I. Summary of EKPC's modeling approach

II. The IRP should consider full gas conversion or retirement of some its coal units

This is to certify that the foregoing copy of Sierra Club's Comments on East Kentucky Power Cooperative, Inc.'s 2025 Integrated Resource Plan in this action is being electronically transmitted to the Commission on September 11, 2025, and that there are currently no parties that the Commission has excused from participation by electronic means in this proceeding.

Figure 1: Plant Cooper Energy Revenues and Costs (\$mil)¹⁰

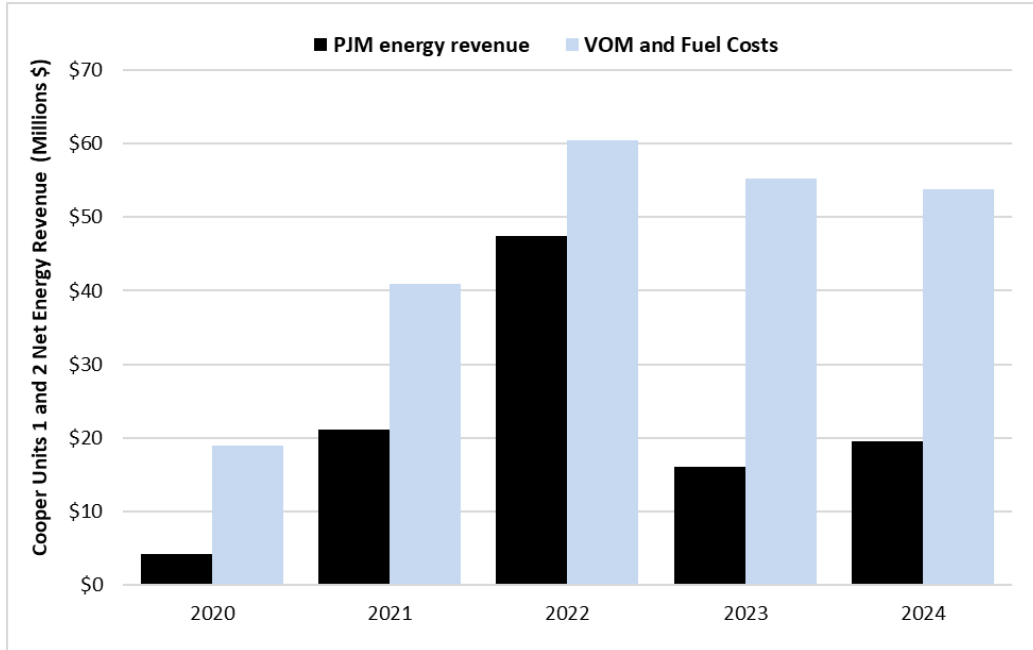
In its preferred plan, the Company allows for 100 percent gas at Cooper Unit 2, but with the possibility of co-firing with coal, despite its uneconomic performance running on coal.⁸ The Company also plans to mothball Cooper 1 and use it essentially as a backup resource. EKPC should have considered both units for retirement and also considered Cooper 2 for full gas conversion, rather than leaving the door open for further coal usage. In order to be economic in a wholesale market, coal units should at a minimum generate more energy revenue than they cost to produce. Because ratepayers are paying for the units' operating costs and benefitting from the market revenue from the units' sales, if the former outweighs the latter then ratepayers are paying more for energy than they should. Unfortunately, that is the case for the Cooper plant, which has been operating at a loss on the energy market for at least the past five years as shown in Figure 1.⁹

Figure 2: Cooper Units 1 and 2 Historical Capacity Factor¹¹

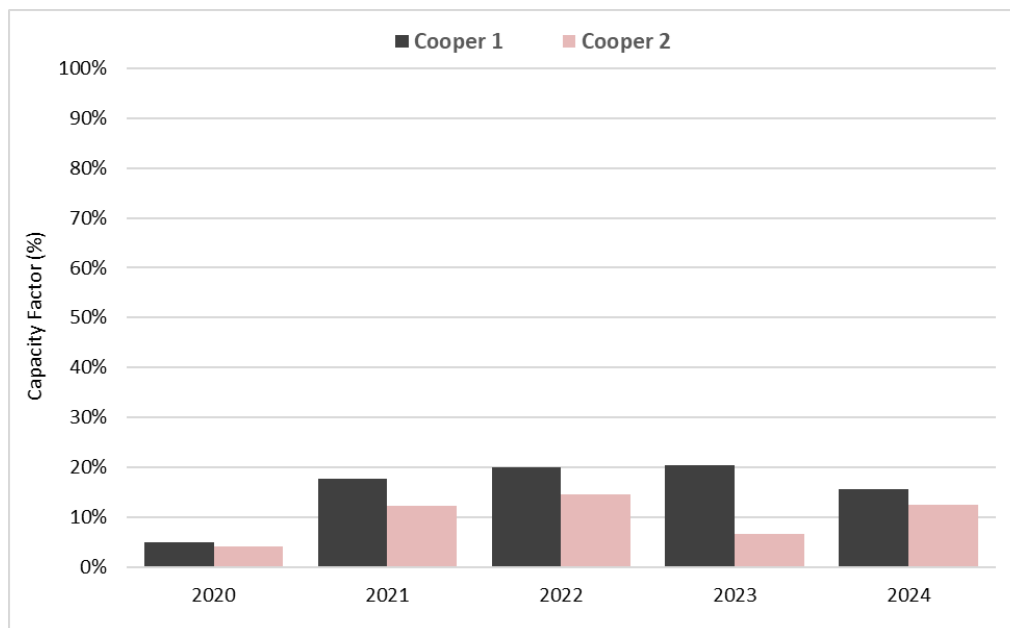
These units are losing money and costing ratepayers because they both operate as peaking units while running on coal—as shown below in Figure 2. The units have operated at an average of a 13 percent capacity factor from 2020 through 2024, with the highest level in the past five years being 20 percent for Cooper 2 in 2022 and 2023.

Cooper Unit 2 has operated the least frequently of any of the EKPC’s units because it has high fuel costs and is highly inefficient, therefore it is costly to dispatch. The fuel costs in 2024 were nearly █ per MMBtu, █ the price of natural gas at that time.¹² Over the past five years, Cooper Unit 2 has an average heat rate of above 11 MMBtu/MWh, the highest of all the EKPC coal units except Cooper 1.¹³ This means that in terms of *fuel costs only* the unit costs █ per MWh to run on coal. Given the unit’s high costs and poor performance—leading to negative net energy revenues—the Company should have at least considered converting the unit fully to gas or retiring it fully.

Figure 3. NREL 2024 capital costs for 4-hour battery storage resources (2022\$/kW)²⁶

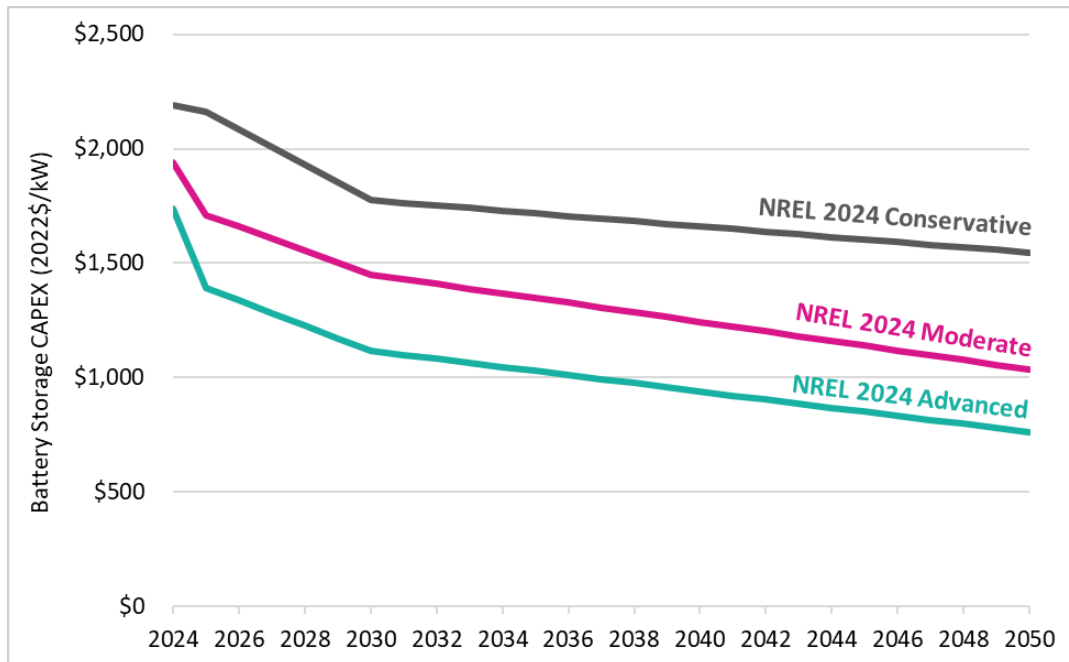
When assuming high capital costs for a resource, an optimization model is less likely to select that resource. EKPC's modeling assumes a projected capital cost of \$2,190 per kW for battery storage resources, based on the National Renewable Energy Laboratory's ("NREL") 2024 Annual Technology Baseline ("ATB").²⁵ However, this capital cost assumption is based on the NREL 2024 ATB Conservative case, which is substantially higher compared to the Moderate and Advanced cases modeled by NREL (see Figure 3).

EKPC should assume the Moderate case from NREL rather than the high case, allowing battery storage to be more competitive as a replacement resource.
